# Access Compliance Report

## Public Rights-of-Way

### (Curb Ramps)

Intersection ID: 4801	Main Street: ARKLOW_RD	Cross Street: KARYLSTURN_CT	Location: S
ADA ID: 932297F47BF8	Ramp Type: Perp	Initial Pass/Fail: Fail	Overall Compliance: No
		Severity Score: 72.5

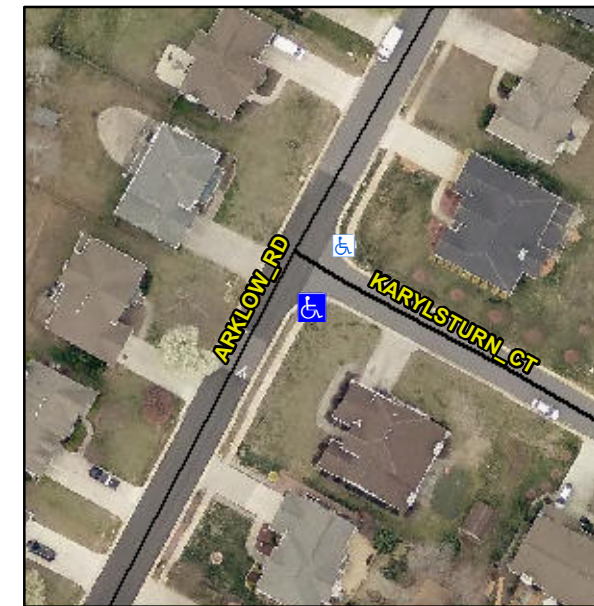
**R304.5.1, R304.2.2, R304.5.3**

Compliance	Description	Data	Compliance	Description	Data
N/A	Ramp Length (in)	47.0	No	Ramp Slope (%)	11.1
No	Ramp Width (in)	31.0	No	Ramp XSlope (%)	7.3
N/A	Flare Type LT	N/A	N/A	Flare Type RT	N/A
N/A	Flare Slope LT (%)	N/A	N/A	Flare Slope RT (%)	N/A
N/A	Flare Traversable LT?	N/A	N/A	Flare Traversable RT?	N/A
N/A	Landing Length (in)	N/A	N/A	DWS Provided?	N/A
N/A	Landing Width (in)	N/A	N/A	DWS Contrast?	N/A
N/A	Landing Slope (%)	N/A	N/A	DWS Length (in)	N/A
N/A	Landing X Slope (%)	N/A	N/A	DWS Full Width?	N/A
N/A	Landing Curb? (Y/N)	N/A	N/A	DWS Offset (in)	N/A
N/A	Shared Landing?	N/A			
N/A	Gutter Ponding?	N/A	N/A	Gutter Slope (%)	N/A
N/A	Gutter Lip Ht (in)	N/A	N/A	Gutter X Slope (%)	N/A
N/A	Painted X Walk1?	No	N/A	Painted X Walk2?	N/A
	X Walk 1 Direction	To NE		X Walk 2 Direction	N/A
N/A	X Walk 1 Width (in)	N/A	N/A	X Walk 2 Width (in)	N/A
	X Walk 1 Slope (%)	0.2		X Walk 2 Slope (%)	N/A
	X Walk 1 X Slope (%)	9.0		X Walk 2 X Slope (%)	N/A

**Remove & Replace Entire Ramp.**
